TI 1101 – TD dryer belt tension

MACHINES AFFECTED: TD30, TD50, TD75, all versions produced from 6/2002 through 1/2003.

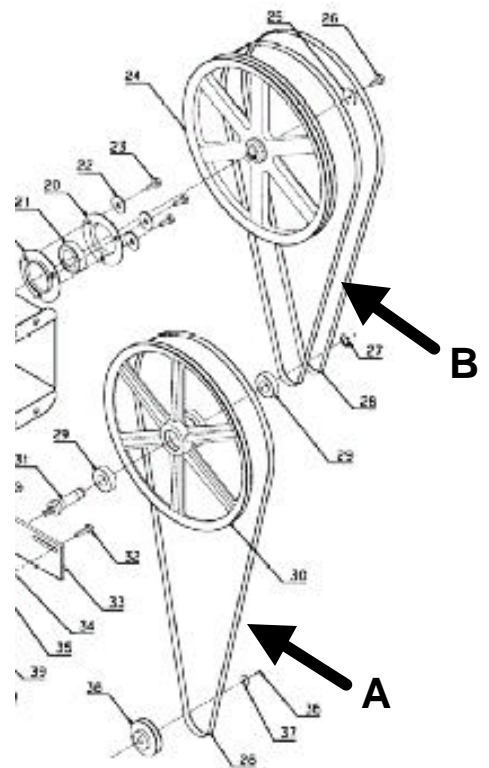
On TD30, TD50 and TD75 dryers produced between June, 2002 and January 2003, it has been determined that the drive belts may have been over tightened during assembly of some machines. On the next service visit, it is recommended that the drive belt tension be inspected, and adjusted, as necessary.

Note that “A” is the point on the free length of the belt, half way between the motor pulley and the idler pulley. “B” is the point on the free length of the belt(s), half way between the idler pulley and the drum pulley.

The table below provides correct tension data for the drive belts on these models. Note that the tension may be checked by force/deflection measurement or by measuring the response frequency of the belt when plucked.

MODEL	FORCE (pounds)	BELT DEFLECTION (inch)		RESONANT FREQUENCY (min / max) Hz
		New belt	Used belt	
TD30				
Point A	6	3/8	1/2	75 to 95
Point B	6	1/4	3/8	100 to 120
TD50				
Point A	6	3/8	1/2	75 to 95
Point B	6	1/4	3/8	100 to 120
TD75				
Point A	5	3/8	1/2	65 to 90
Point B	5	1/4	3/8	75 to 100
